APPENDIX E

Four-Factor Analyses

Subject: Notification of request for 4-factor analysis on control scenarios under the Clean Air Act
Regional Haze Program

Subject: Additional clarifications on DCP's Chitwood Gas Plant 4-factor analysis on control scenarios under the Clean Air Act Regional Haze Program

Updated Figure 3-1. Observations and Model Predictions Compared to Glidepath for WIMO

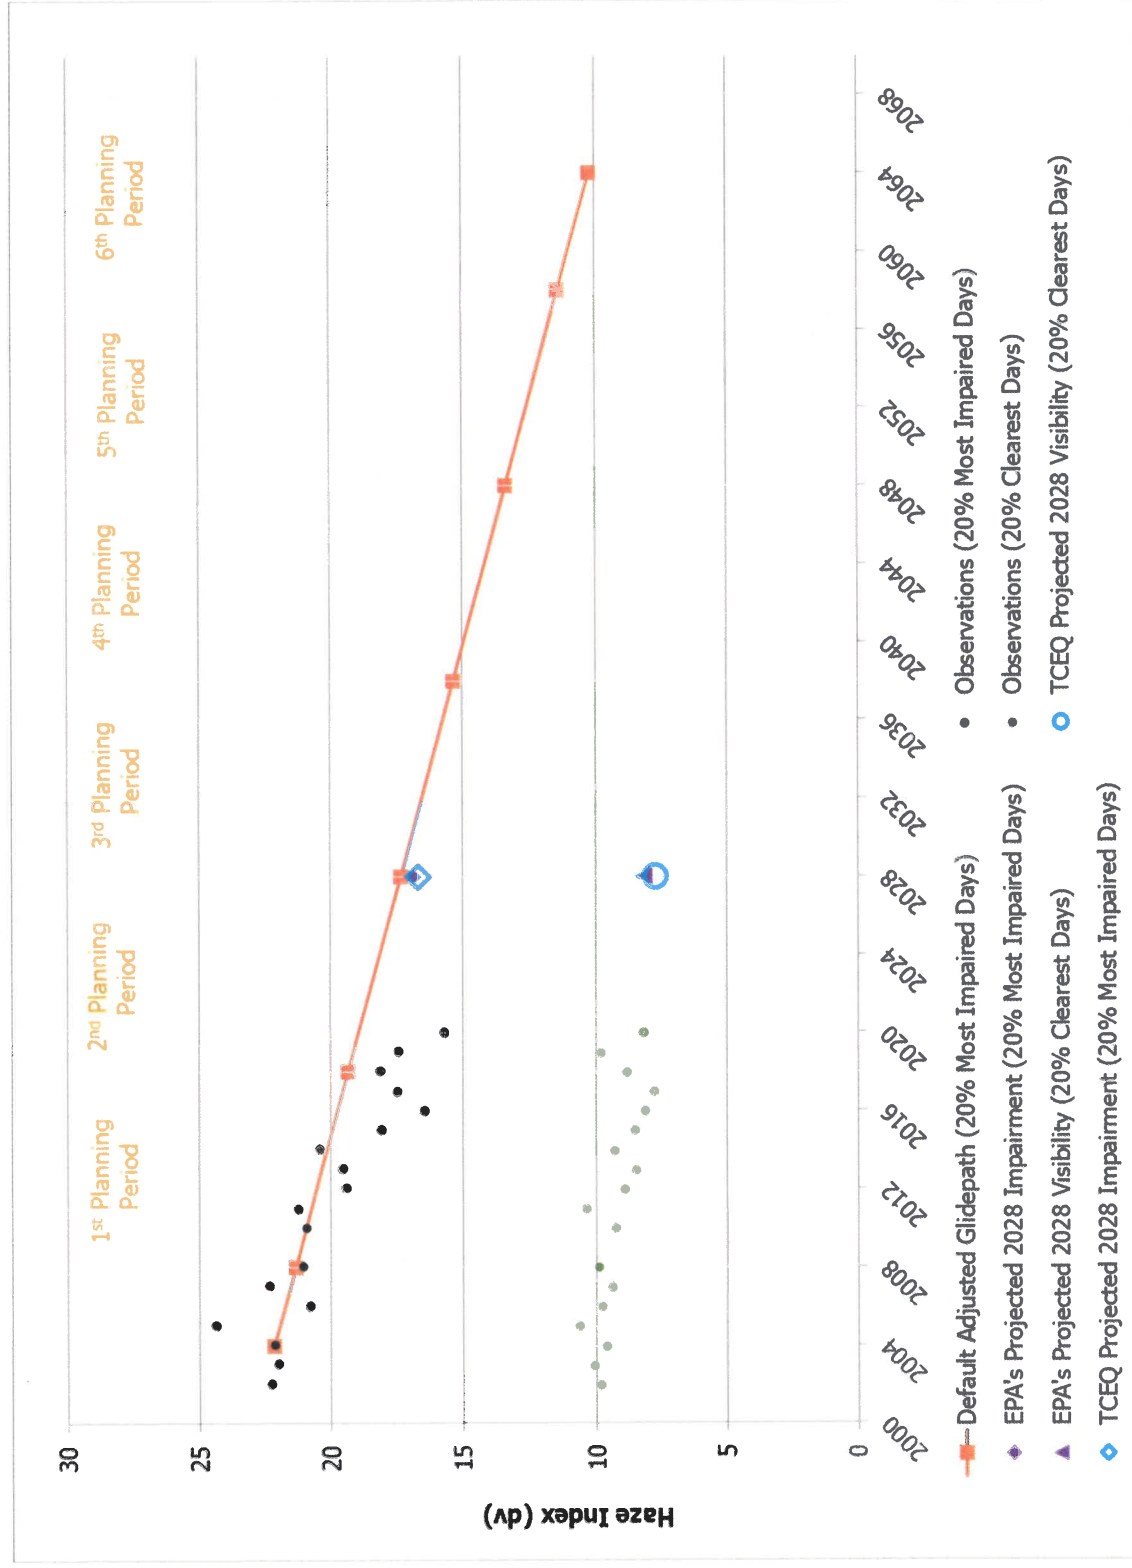
In addition to these replies, OG&E is providing one update to its September 29, 2020 *Regional Haze Four-Factor Reasonable Progress Analysis* submittal. Figure 3-1 in Appendix B of that submittal has been updated to include the most recent Class I area observation data (for years 2019 and 2020). The updated version is enclosed. It demonstrates that actual visibility conditions in the Wichita Mountains have continued to improve, and this substantiates the conclusions drawn in OG&E's submittal – primarily that no additional controls are needed for this planning period.

Enclosure Updated Figure 3-1 from Appendix B of OG&E's September 29, 2020 *Regional Haze Four-Factor Reasonable Progress Analysis* submittal
